# COX DESIGN ASSOCIATES

## MeMO

**TO:** MICHELE MILLERS  
**FROM:** BOB COX  
**RE:** PRE-BID RESPONSE TO CONTRACTORS' QUESTIONS.  
**PROJECT:** A/E SERVICES TO RENOVATE 4E AND 5E PROJECT 636A8-11-001  
**DATE:** 31 May '12; 6 Jun '12; 8 Jun '12; 11 Jun '12

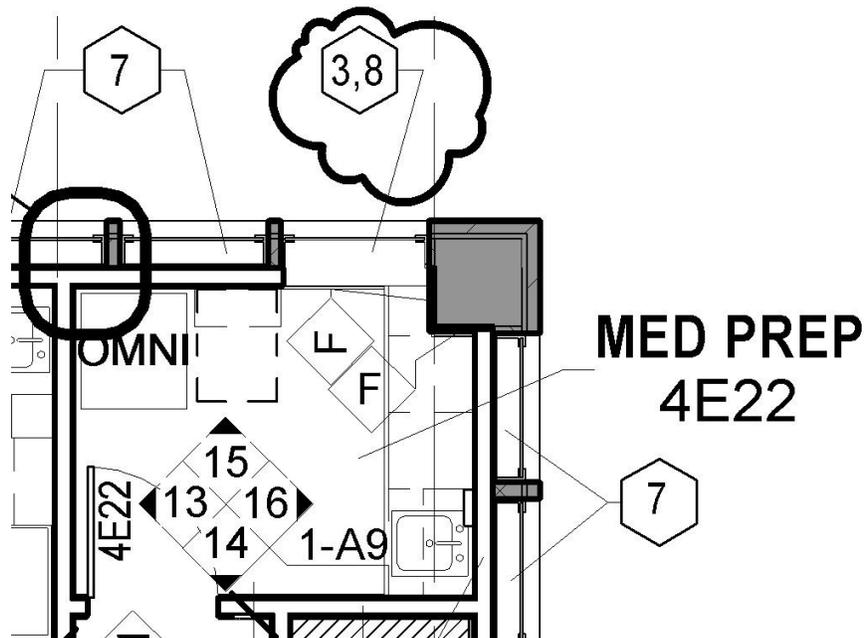
41. Question: Similar condition for Prep RM 13 4E13 and Med Prep 4E22 are you asking for 2 new inserts in the Prep RM 13 4E13 and 1 new insert in Med Prep 4E22?

**Answer:** Yes, for Prep Room 4E13, see Sheet 1-A4, Key Note 8 and Sheet 1-A8 Typical Detail 10. For Med Prep Room 4E22, see Sheet 1-A9, Detail 15. Additionally, for clarification refer to the sketch below for inclusion of Key Notes 3 and 8 and delete 4.
